Subject: LaSalle County Nuclear Power Station, Units 1 and 2
Application for Amendment of Facility Operating
Licenses NPF-11 and NPF-18, Appendix A, Technical
Specifications, Improvements to Control Room Air
Intake Radiation Monitoring Logic.
NRC Docket Nos. 50-373 and 50-374

**DESCRIPTION AND SAFETY ANALYSIS
FOR PROPOSED CHANGES TO**

**MAIN CONTROL ROOM ATMOSPHERIC CONTROL SYSTEM RADIATION
MONITORING INSTRUMENTATION TECHNICAL SPECIFICATION**

FIGURE 2

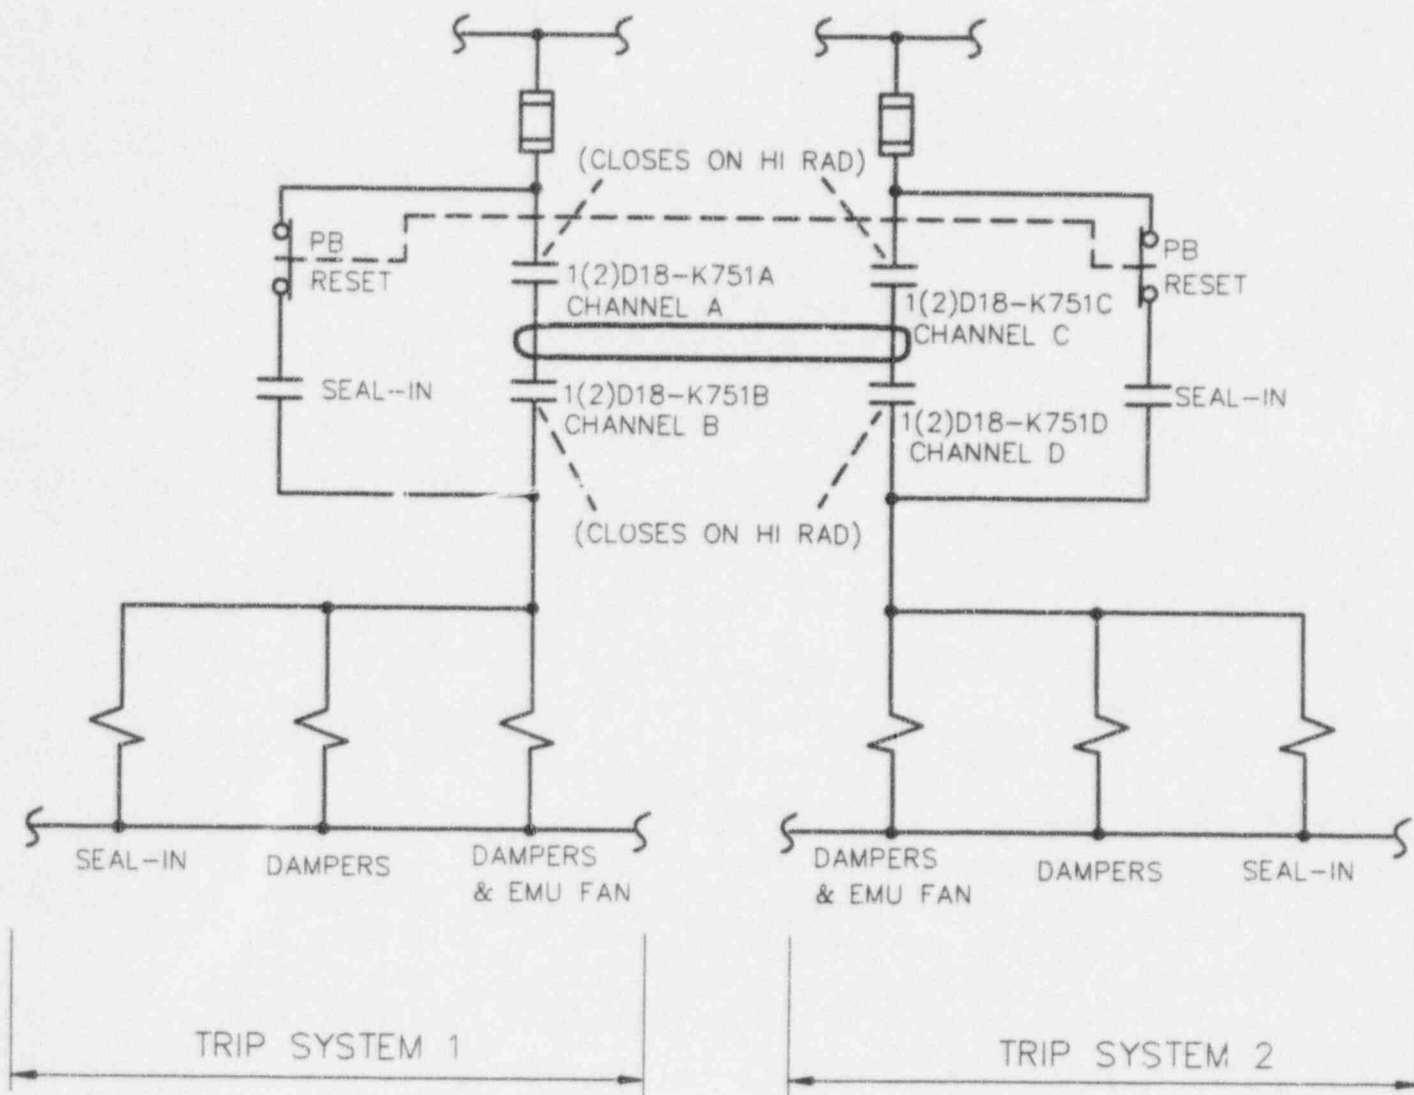
The system actually consists of two independent "trip systems" per train. Each trip system includes two radiation monitor channels. For clarity and consistency, the radiation monitors for each ventilation train will be hereafter defined as channels A, B, C, and D, and the trip systems defined as Trip System 1 and Trip System 2. See Figure 1 for a schematic of the Current Configuration of Trip Systems and Figure 2 for the proposed Modified Configuration.

Following modification of the Radiation Monitoring trip system, the logic scheme will consist of two monitors(channels) and one trip relay per trip system with two trip systems per radiation monitor subsystem. A trip of both channels in a trip system will be required to initiate the associated Control Room Emergency Filtration subsystem (CREFS) in the pressurization mode of operation. Either trip system will initiate the associated CREFS. The overall control logic for the remaining portions of the CREFS is not changed by the design change.
